**Attachment 1
NRC3-12-0003**

**Table of RAI Response Dates
(5 pages)**

Response to RAI Letter No. 70
(eRAI Tracking No. 6217)

Figure 8: Comparison of mean of response spectra (5 percent damping) for weakly matched time histories to the target DE spectra for the 10^{-6} low frequency (LF) motions

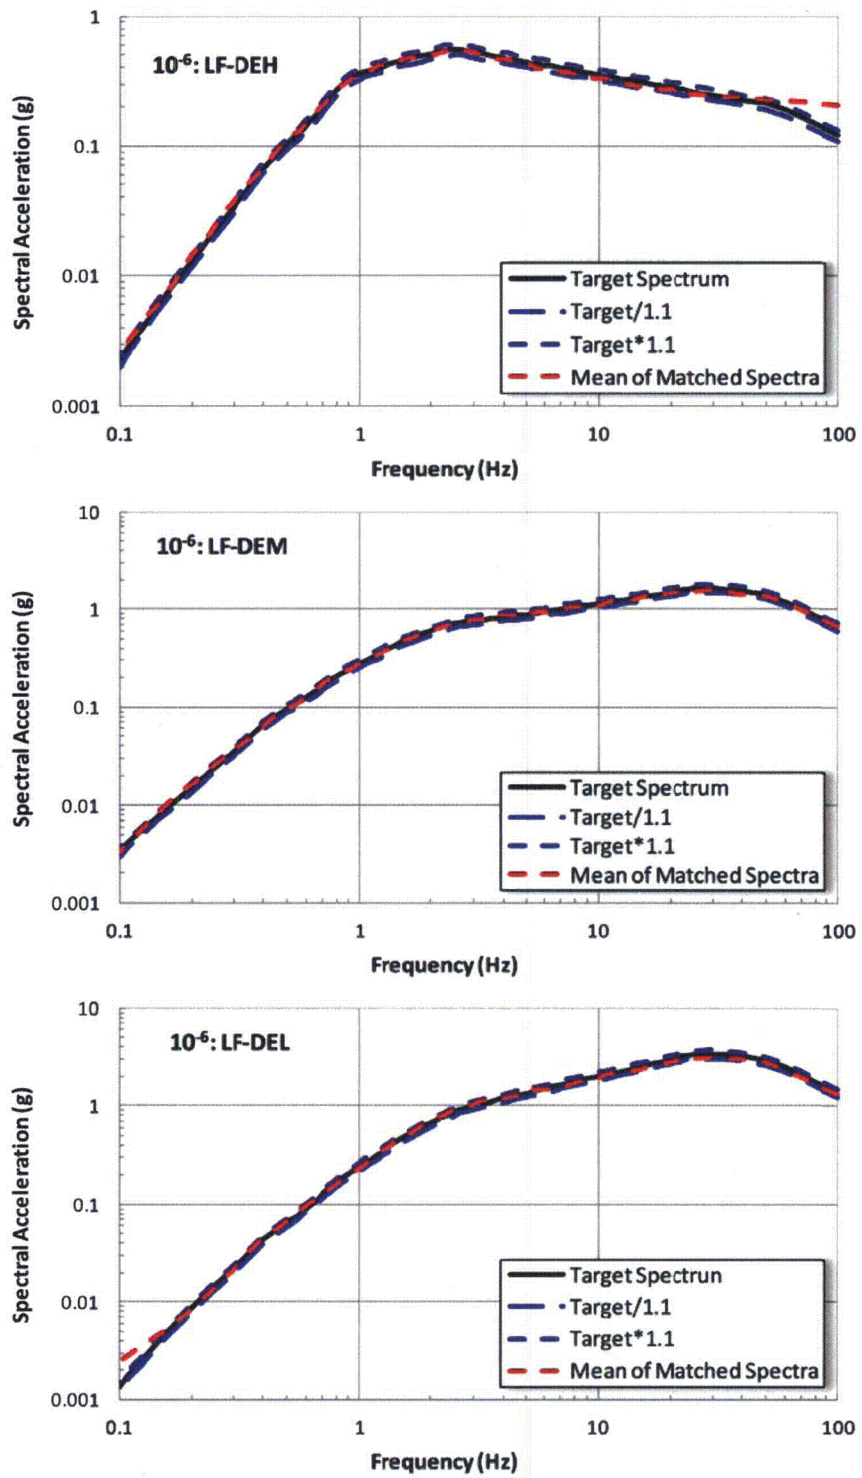
FSAR Section 2.5.2.5.2 indicates that the selected time histories were scaled to approximately match the target DE spectrum using a limited number of iterations of the program RASCALS. Please provide more detail regarding the scaling process. In addition, please quantitatively compare the mean response spectrum of each suite of scaled time histories to the respective target spectrum.

DE target response spectra were developed to represent the contributions to the Fermi 3 site hazard for high frequency (HF) and low frequency (LF) ground motions. DE spectra were developed for hazard levels corresponding to 10^{-3} , 10^{-4} , 10^{-5} , and 10^{-6} mean annual frequencies of exceedance. The target magnitudes and distances for each DE are listed in FSAR Table 2.5.2-219. For each case, three DE spectra are defined: a high magnitude target, DEH; an intermediate magnitude target, DEM; and a low magnitude target, DEL. As described in FSAR Subsection 2.5.2.5.2, the 30 time histories in the appropriate magnitude and distance bin of the central and eastern United States (CEUS) time history database in NUREG/CR-6728 (McGuire et al., 2001) were weakly matched to each DE spectrum. Figures 1 through 8 compare the target DE spectra to the mean response spectra for the 30 scaled time histories for HF and LF motions at the four hazard levels. Each plot also shows the target DE spectrum multiplied by 1.1 and divided by 1.1 to provide a sense of the accuracy of the average fit.

The comparisons shown on Figures 1 through 8 show that the means of the response spectral ordinates for the scaled time histories are generally within a factor of 1.1 of the target DE response spectrum. All spectra shown on the figures are for 5 percent damping. In some cases, large deviations from the target spectrum occur at frequencies below about 0.2 Hz. Because the fundamental frequencies of the site profiles are approximately 3 Hz, the deviations at very low frequencies have little impact, as indicated by the amplification factors near unity for frequencies less than 1 Hz (e.g., FSAR Figure 2.5.2-270). In a few cases for the LF DE spectra (LF DEH for 10^{-5} and 10^{-6}), large deviations from the target spectrum occur at frequencies above 50 Hz. These deviations are not significant because the motions in this frequency range are not used to define the LF site amplification factors.

The results shown on Figures 1 through 8 indicate that the mean of the response spectra for the weakly scaled time histories provide a good representation of the DE target response spectra.

Figure 3.7.1-228: Fermi 3 Horizontal RB/FB SCOR FIRS and Enhanced SCOR FIRS (5% Damping).

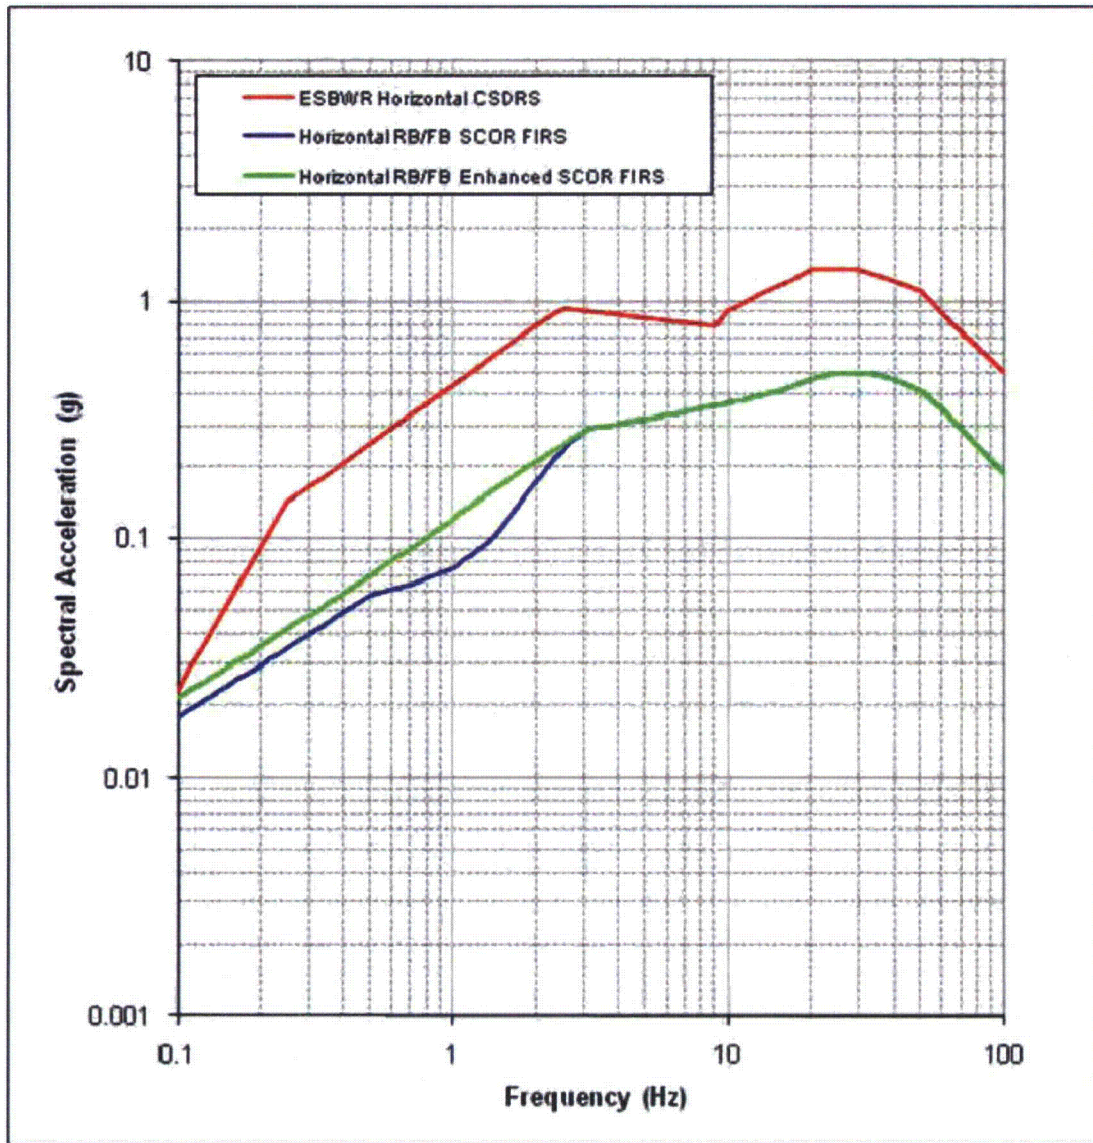
EF3 FSAR Section 3.7.1.1.5, Table 3.7.1-212, and Table 3.7.1-212, as modified by the markups included with the response to RAI Letter 55 Question 02.05.04-38, indicate that the two horizontal components of spectrum-compatible ground motion used in the seismic SSI analysis have correlation coefficients slightly under 0.30. This deviates from the guidance in SRP 3.7.1, which states that the three orthogonal components of ground motion are considered to be statistically independent if their correlation coefficient is less than 0.16.

Based on the above discussion, the staff needs additional technical basis for using two components of ground motion with correlation coefficient of approximately 0.30. If Regulatory Position C.2.2(2) of RG 1.92 is used for determining the total site-specific seismic demand for the SSCs, the applicant is requested to provide a comparison with the seismic demand as determined from the use of Regulatory Position C.2.2(1), and demonstrate that the current site-specific seismic demand as specified in EF3 FSAR is not under predicted.

The horizontal SCOR FIRS were then enhanced by increasing the overall level of ground motion in the frequency ranges identified during the comparison of the resulting envelope of the three surface spectra from the time histories and the PBSRS. Figure 3.7.1-228 and Figure 3.7.1-229 show the horizontal SCOR FIRS and the horizontal enhanced SCOR FIRS for the RB/FB and CB, respectively. Also shown on Figure 3.7.1-228 and Figure 3.7.1-229 are the horizontal ESBWR CSDRS (Reference 2.5.2-291). The enhanced horizontal SCOR FIRS for the RB/FB and CB are enveloped by the horizontal ESBWR CSDRS. Time histories matched to the enhanced SCOR FIRS were then convolved from the foundation level up to the finished ground level grade using the full soil column LB, BE, and UB subsurface profiles for comparison to the PBSRS at the finished ground level grade. Figure 3.7.1-230 to Figure 3.7.1-231 show the comparison of the PBSRS at the finished ground level grade with the envelope of the surface response spectra obtained from SHAKE analyses using the LB, BE, and UB full soil column profiles and the matched time histories compatible with the RB/FB and CB enhanced SCOR FIRS, respectively. The envelope of the three response spectra at the ground surface exceeds the PBSRS at the finished ground level grade for each component of motion, satisfying the Interim Staff Guidance DC/COL-ISG-017 and the NEI developed white paper (Reference 3.7.1-206). The RB/FB and CB enhanced horizontal SCOR FIRS values are provided in Table 3.7.1-210 and Table 3.7.1-211, respectively.
